CASE NO. SP2020-007

RE: REVISION NARRATIVE – AMENDED SITE PLAN SUBMITTAL

The following changes have been made to the previous approved site plan.

SPR PACKAGING
 OFFICE ADDITION
 1480 JUSTIN RD., ROCKWALL, TEXAS

1 SOUTH ELEVATION
SCALE: 1/8"=1'-0" FACES JUSTIN RD.

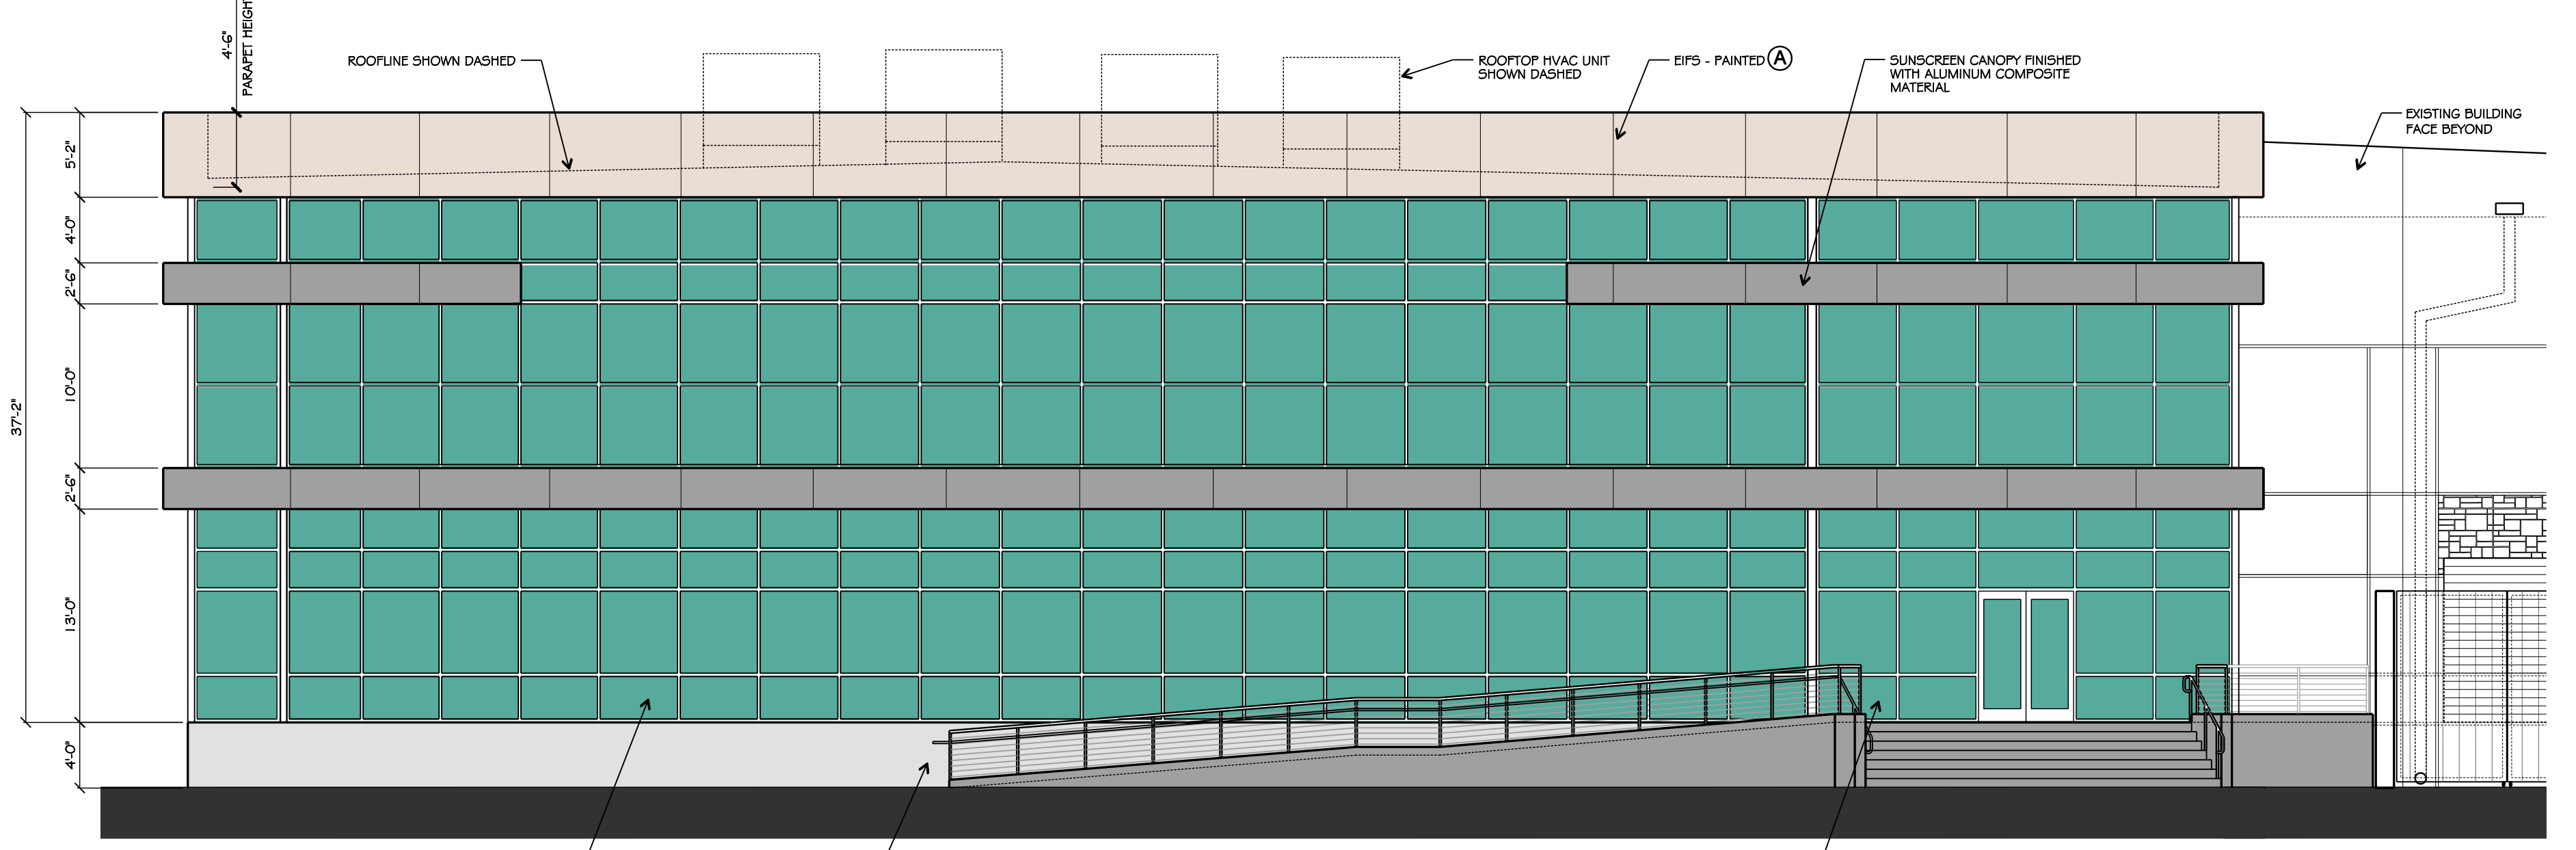
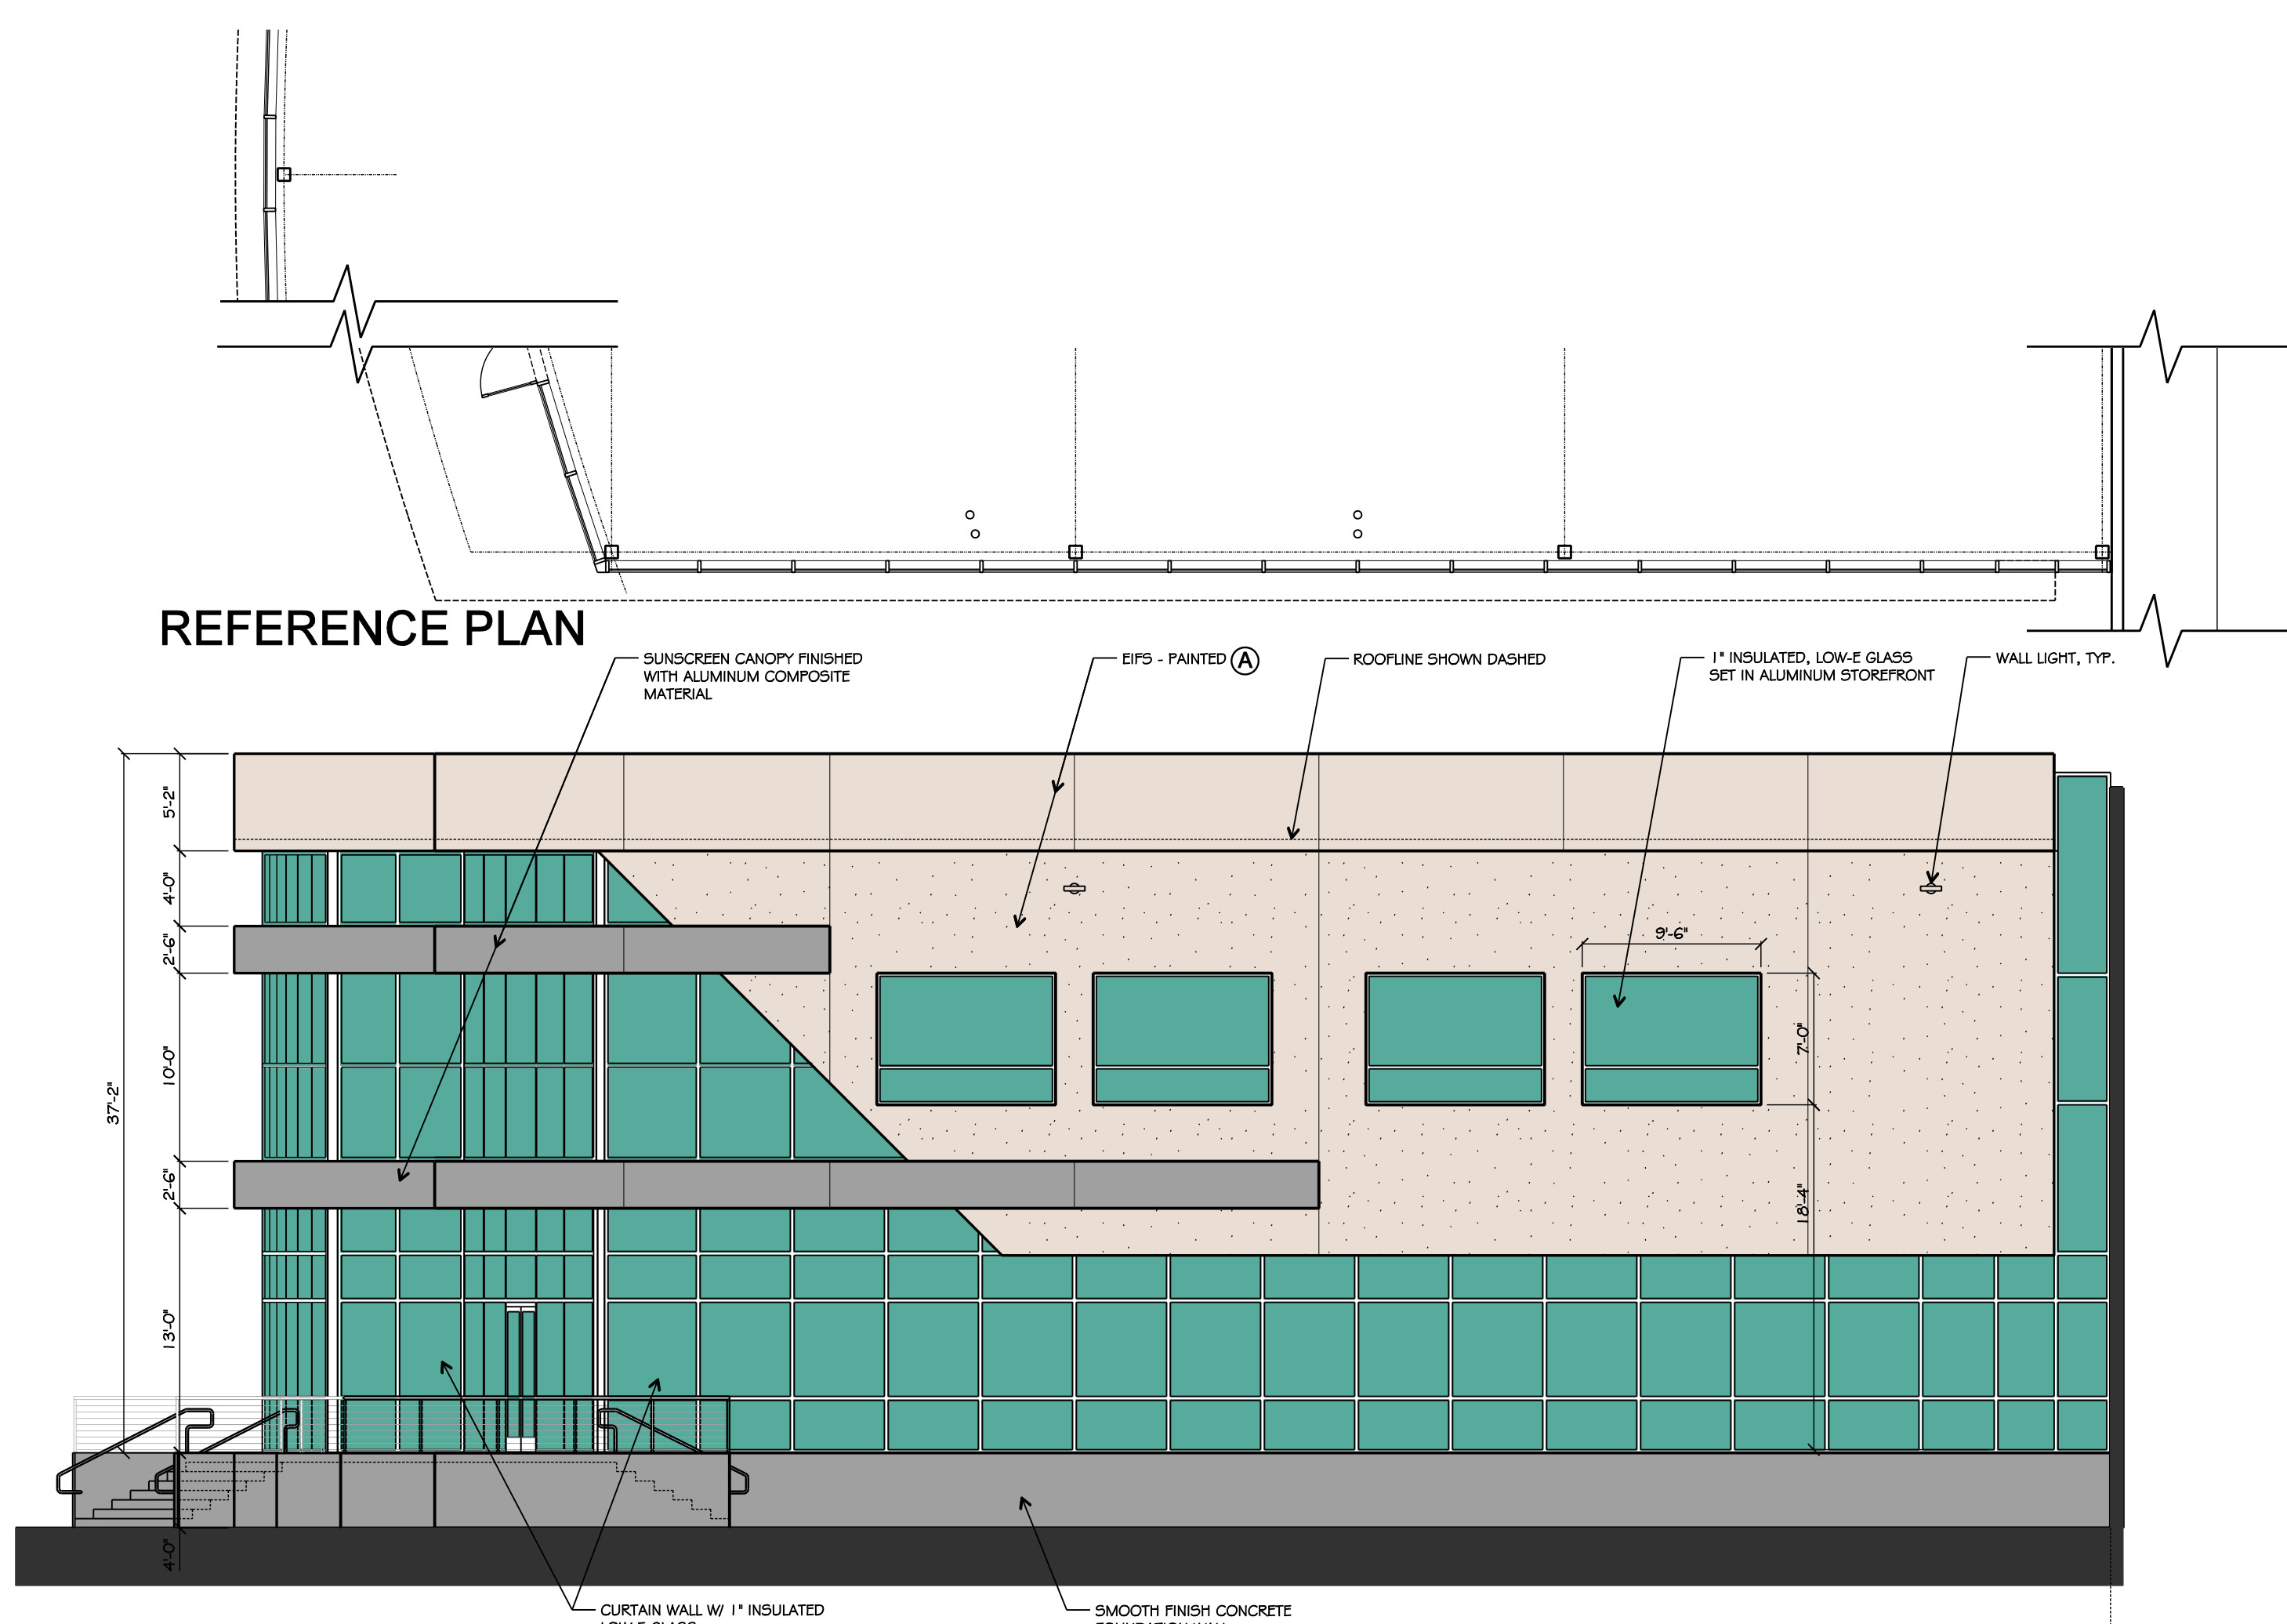
- Elevations are revised to show the new location of the compactor enclosure and the correct depiction of the entry stairs to the future locker room portion.
